Access Compliance Report

Public Rights-of-Way

Intersection ID: 45735	Main Street: REDWOOD VALLEY LN	Cross Street: COPPER LEAF LN	Location: NW
ADA ID: BBE439AB1B68	Ramp Type: PerpDiag	Initial Pass/Fail: Fail	Overall Compliance: No
Severity Score: 10			
Codes/Mitigation Info/Possible Solution		Field Measurements/Component Compliance

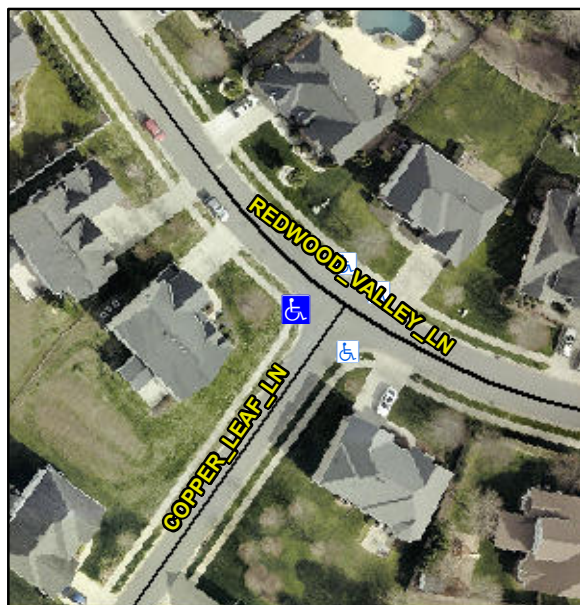
Not Found, R304.5.1, R304.5.3

Compliance	Description	Data	Compliance	Description	Data
N/A	Ramp Length (in)	49.0	Yes	Ramp Slope (%)	8.1
No	Ramp Width (in)	46.0	No	Ramp XSlope (%)	2.9
N/A	Flare Type LT	N/A	N/A	Flare Type RT	N/A
N/A	Flare Slope LT (%)	N/A	N/A	Flare Slope RT (%)	N/A
N/A	Flare Traversable LT?	N/A	N/A	Flare Traversable RT?	N/A
N/A	Landing Length (in)	N/A	N/A	DWS Provided?	N/A
N/A	Landing Width (in)	N/A	N/A	DWS Contrast?	N/A
N/A	Landing Slope (%)	N/A	N/A	DWS Length (in)	N/A
N/A	Landing X Slope (%)	N/A	N/A	DWS Full Width?	N/A
N/A	Landing Curb? (Y/N)	N/A	N/A	DWS Offset (in)	N/A
N/A	Shared Landing?	N/A			
N/A	Gutter Ponding?	N/A	N/A	Gutter Slope (%)	N/A
N/A	Gutter Lip Ht (in)	1.8	N/A	Gutter X Slope (%)	N/A
N/A	Painted X Walk1?	No	N/A	Painted X Walk2?	No
	X Walk 1 Direction	To SE		X Walk 2 Direction	To NE
N/A	X Walk 1 Width (in)	N/A	N/A	X Walk 2 Width (in)	N/A
	X Walk 1 Slope (%)	2.0		X Walk 2 Slope (%)	2.8
	X Walk 1 X Slope (%)	2.3		X Walk 2 X Slope (%)	0.5

Remove & Replace Curb Ramp With Two New Directional Ramps or Equivalent.
